Darwin Ship Lift Supplementary EIS

Supplementary Environmental Impact Statement

Darwin Ship Lift Project

Client: Department of Infrastructure, Planning and Logistics

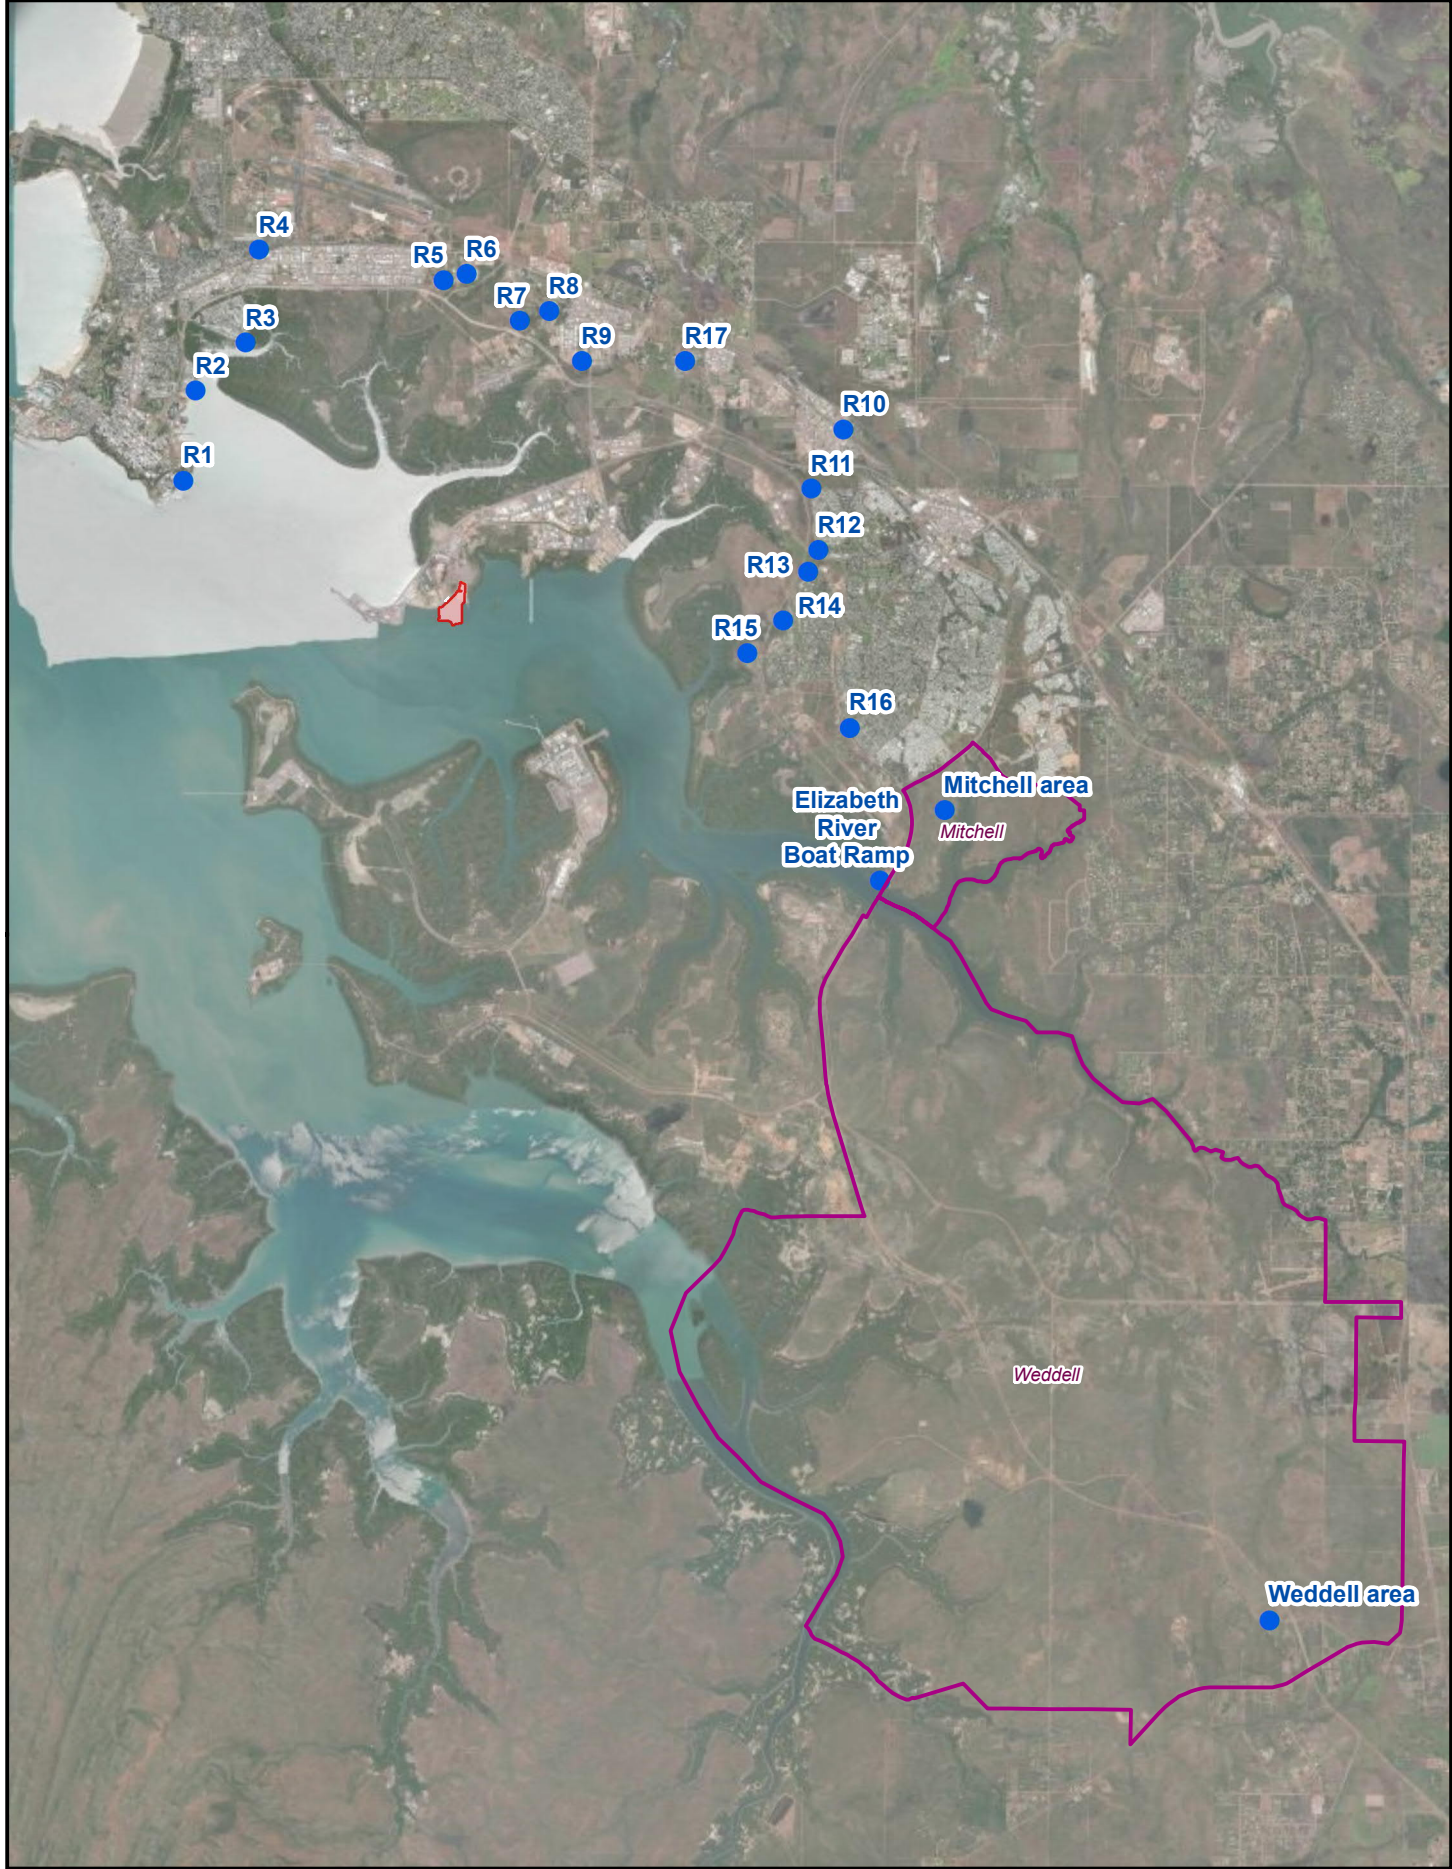
3.1.2.3 Additional Sensitive Receptors

Sensitive receptors included in the AQIA are discussed in detail in Section 9.6 of Chapter 9 of the Draft EIS. DEPWS comment on the AQIA recommended the addition of the future residential suburbs of Mitchell and Weddell, as well as the Elizabeth River Boat Ramp, as sensitive land uses to be considered in the AQIA.

Irrespective of the whether the boat ramp can be classified as a sensitive receptor with respect to air quality, all three of these locations are located further away from the Project and in the same orientation (south-east) as sensitive land uses which have already been considered in the AQIA. The location of the future residential suburbs of Mitchell and Weddell, the Elizabeth River Boat Ramp and the location of the receptors already included in the AQIA are shown in Figure 2.

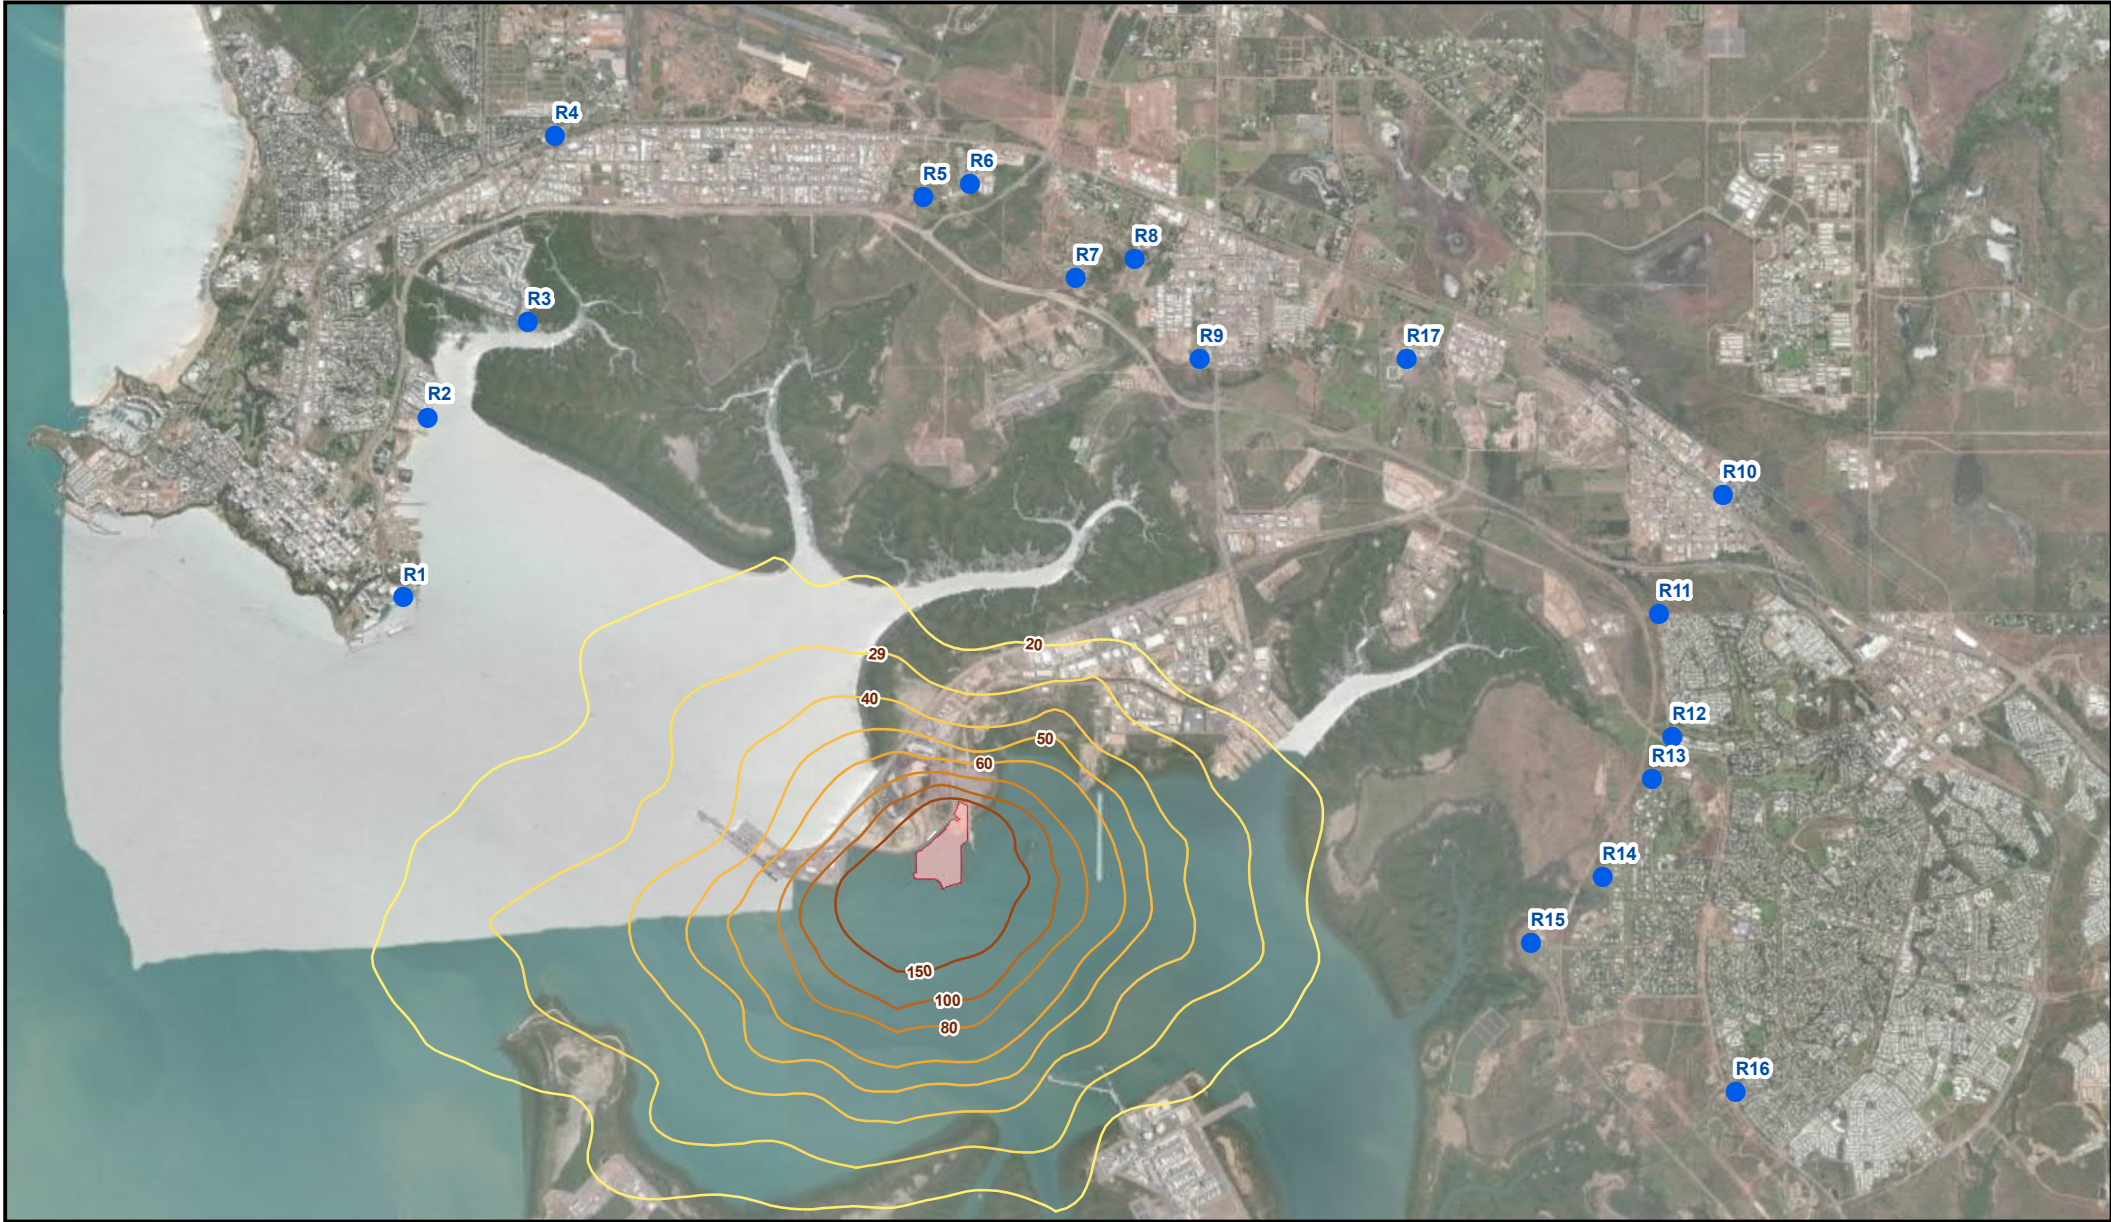
6.1.3 Revised NEPM Criteria Applied to Modelled Results

Proposed amendments to the Draft EIS are provided in the paragraphs below to be implemented into Section 9.7.1.1 of Chapter 9 and Section 7.1.1 of Appendix J of the Draft EIS.

Although the Ambient Air Quality NEPM (2021) air quality goals for NO₂ and SO₂ were not adopted for the AQIA, the modelling results for the construction phase show that compliance with the Ambient Air Quality NEPM (2021) would be achieved at the worst affected receptors, and therefore compliance would be achieved at all receptors if the Ambient Air Quality NEPM (2021) goals were to be applied.

In addition, the concentration contour plot in Figure 6 would be implemented as Figure 9.10b in Chapter 9, and Figure A.7 in Appendix J of the Draft EIS.

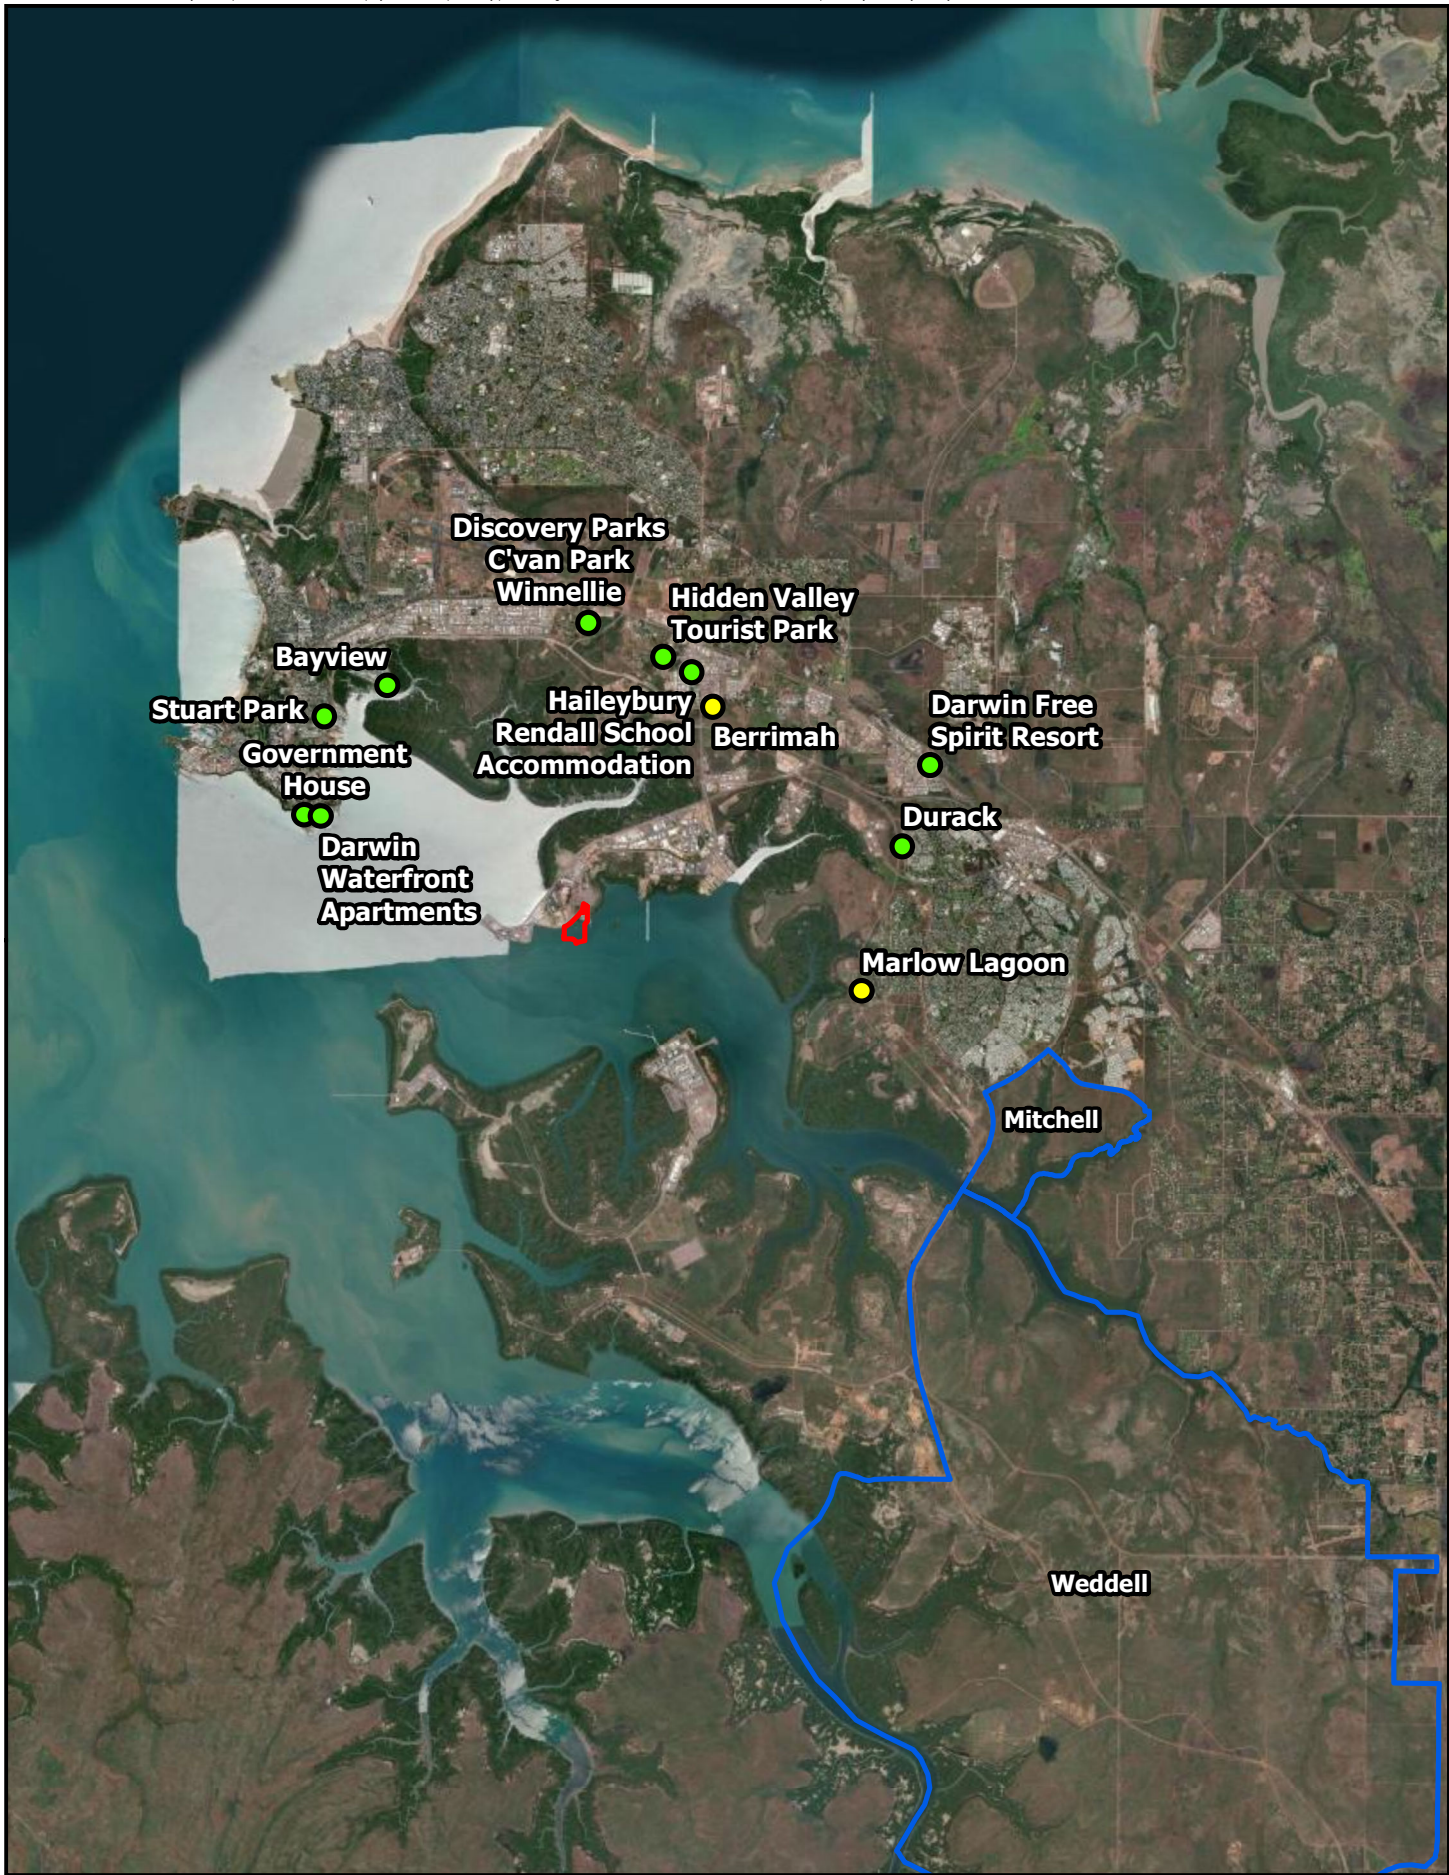
6.2.1 Purpose of this Addendum

This section of the Supplementary EIS presents an addendum to Appendix K: Terrestrial Noise Impact Assessment to consider the additional background noise measurements and to include abrasive blasting in the Proposed activities. This section should be read in conjunction with Appendix K of the Draft EIS.

Proposed amendments to the Draft EIS are provided in the paragraph below to be included in Section 3.1 of Appendix K of the Draft EIS. Figure 4 in the Appendix K to the Draft EIS should be replaced with Figure 8 below.
